**Appendix B –  
Response-to-Comments Table**

**Section 16 Planning Application for Proposed Amendments to an Approved Comprehensive Residential Development Scheme and Minor Relaxation of Gross Floor Area and Building Height Restrictions at Various Lots in D.D. 385 and Adjoining Government Land, Tai Lam Chung, Tuen Mun (Application No. A/TM-SKW/134)**

**Response to Departmental Comments**

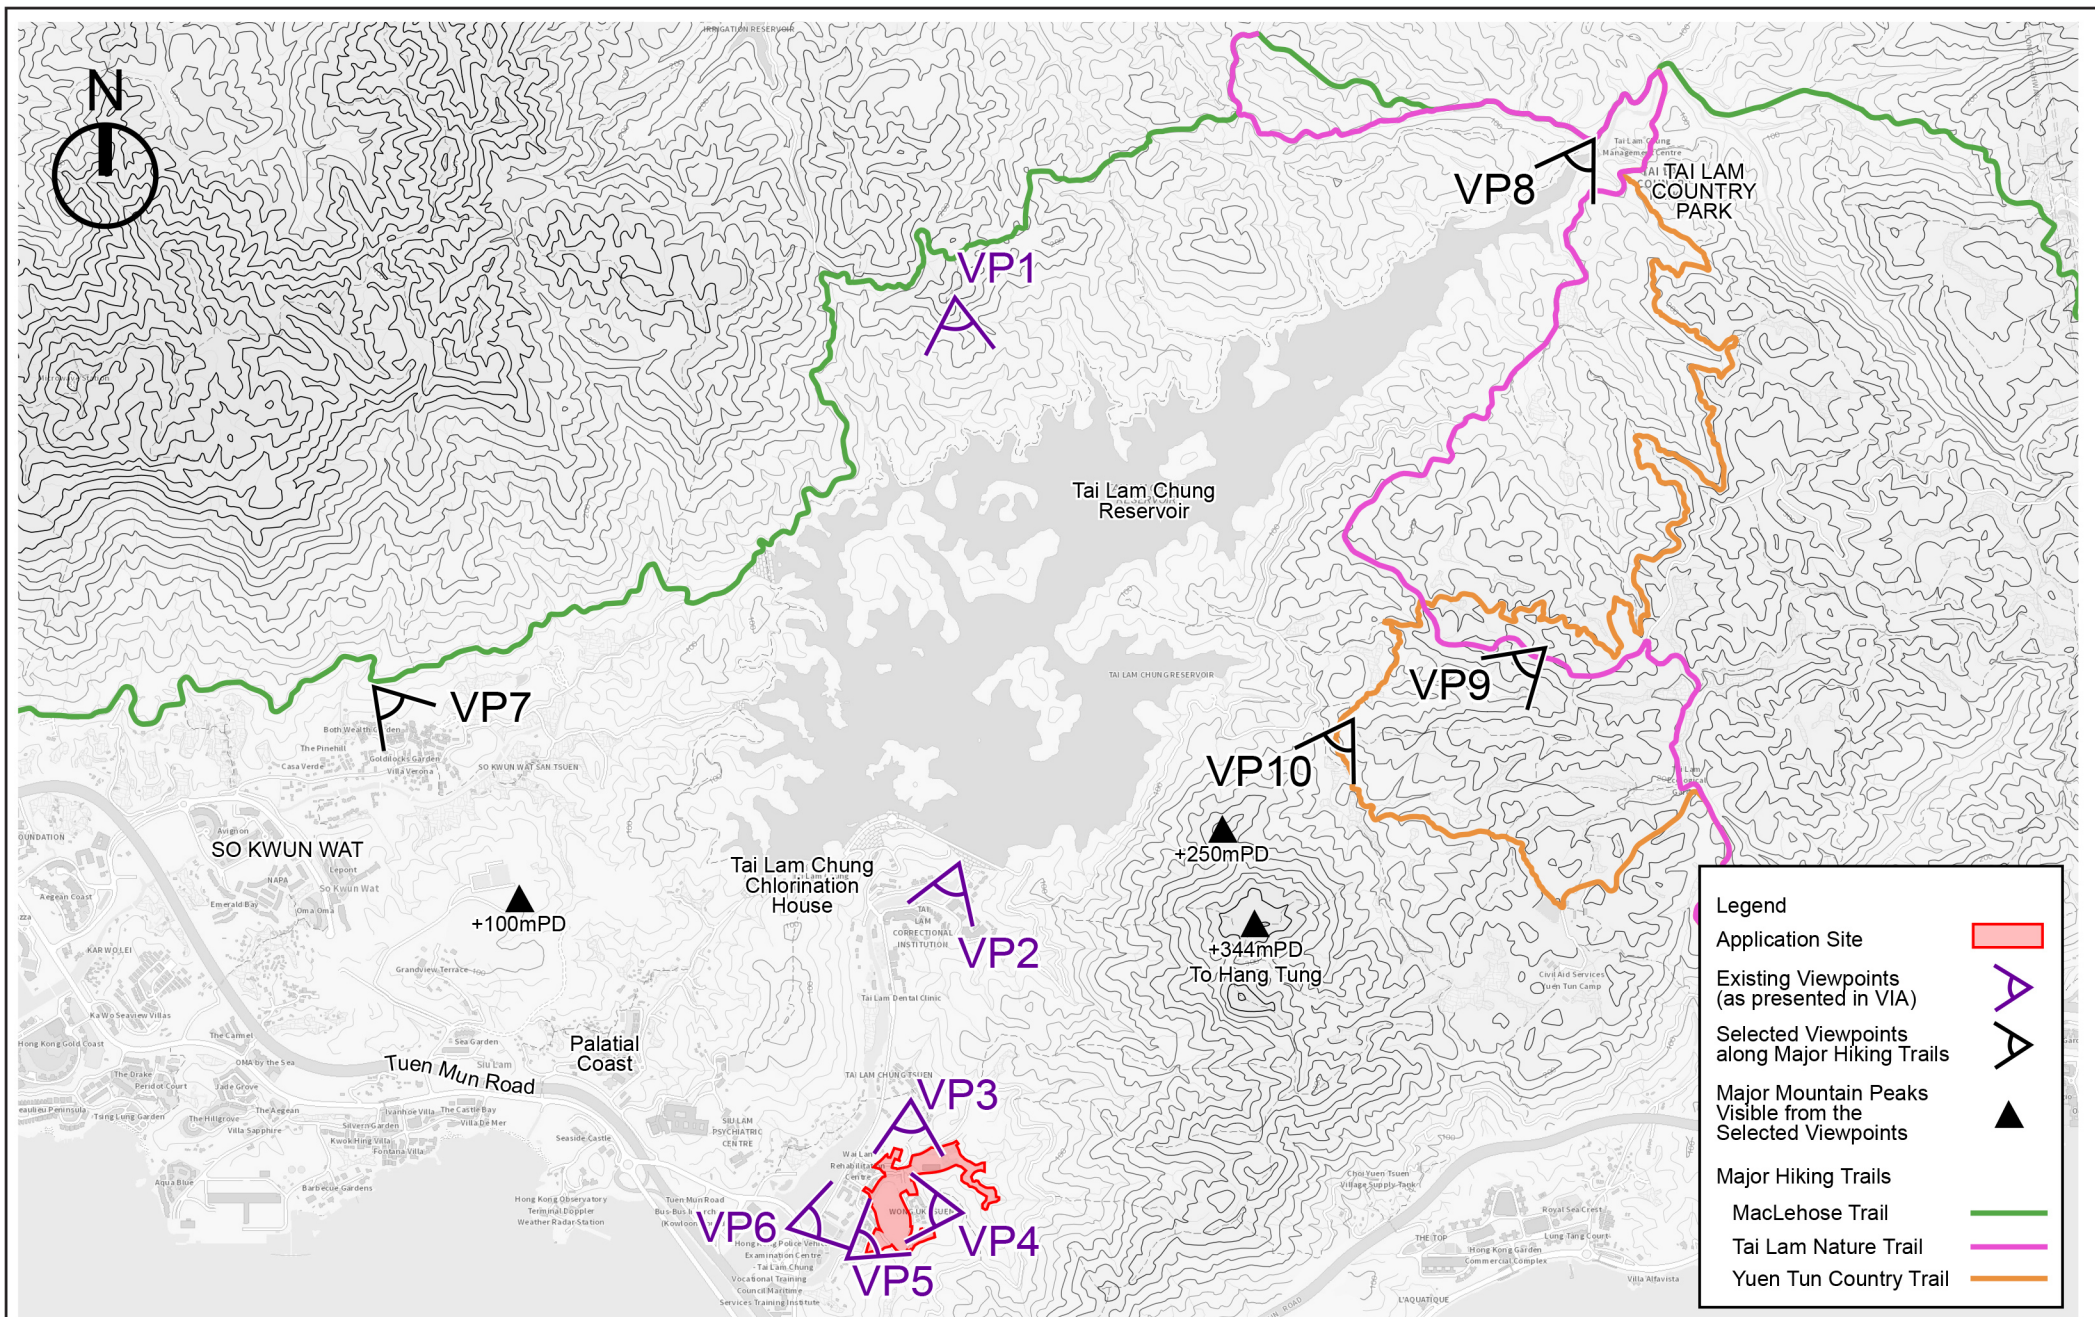
17.11	Dwg. Nos. 60281828/WSIA/407 - For the proposed flushing water mains along Luen Tai Street to the village housing sites, please adopt a size of DNS0 instead of DN40.	Noted. The drawing has been revised accordingly. Please refer to the revised WSIA under <b>Attachment 9</b> .

VP7 – Resting / Lookout Area between Distance Posts M189 and M190, MacLehose Trail

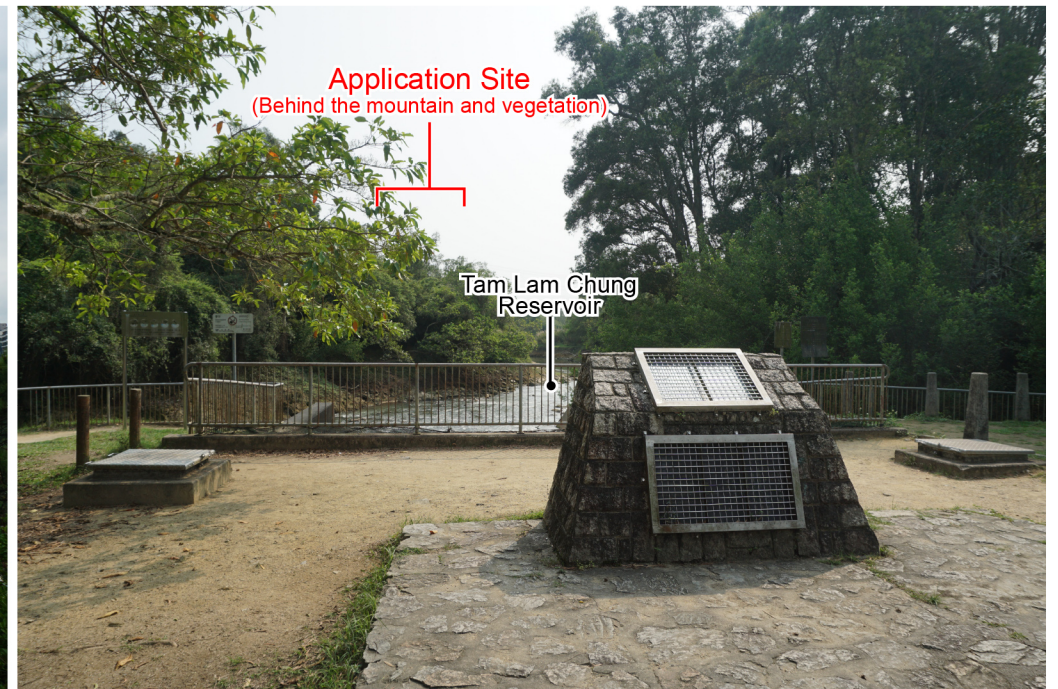
Departmental Comments	Responses to Comments
14.2	<p>The Consultant is reminded to provide relevant information to meet the planning intention/requirements of the subject “Comprehensive Development Area” (“CDA”) zone in the Notes and ES of the subject OZP in particular Para. 10.1.2 (i.e. “in order <b><u>not to block the direct sight line from the walking trails in the Country Park</u></b>, the maximum building height should not exceed 70mPD and 18 storeys.”)</p>	<p>According to AFCD's open dataset “Hiking Trails within Country Parks”, the major hiking trails in the vicinity of the Application Site include MacLehose Trail (Section 10), Tai Lam Nature Trail, and Yuen Tun Country Trail. MacLehose Trail (Section 10) roughly spans in the northeast-southwest direction to the north of Tai Lam Chung Reservoir whereas Tai Lam Nature Trail and Yuen Tun Country Trail roughly span in the north-south direction to the east of the Reservoir. The locations of these trails are shown in <b>Figure A1</b> under <b>Annex A</b> of this RtoC table.</p> <p>To ensure that the Proposed Development does not obstruct the direct line of sight from these trails, four additional viewpoints (VPs) have been selected at strategic locations along these trails to review the potential visual impact of the Proposed Development. These viewpoints include resting areas, picnic areas, and lookout areas where the general public are more likely to stay and enjoy views, and are therefore considered representative of the general view from the three trails towards the Application Site. The location of the selected VPs are shown in <b>Figure A1</b> under <b>Annex A</b> of this RtoC table and listed as follows:</p> <ul style="list-style-type: none"> <li>• VP7 – Resting / Lookout Area between Distance Posts M189 and M190, MacLehose Trail;</li> <li>• VP8 – Picnic Site near Kat Hing Bridge, MacLehose Trail and Tai Lam Nature Trail;</li> <li>• VP9 – Tai Lam Nature Trail Lookout (East); and</li> <li>• VP10 – Distance Post C6308, Yuen Tun Country Trail</li> </ul> <p>The existing views of these VPs are shown in <b>Figures A2 to A3</b> under <b>Annex A</b> of this RtoC table. As shown in the figures, the view towards the Application Site at each of these viewpoints is obstructed by either mountain ridges or existing vegetation in the foreground. Consequently, the Proposed Development would remain unseen from these viewpoints with <b><u>no visual impact</u></b> to the visually sensitive receivers at these VPs. More information about these VPs are in <b>Table A1</b> of <b>Annex A</b> of this RtoC table.</p>
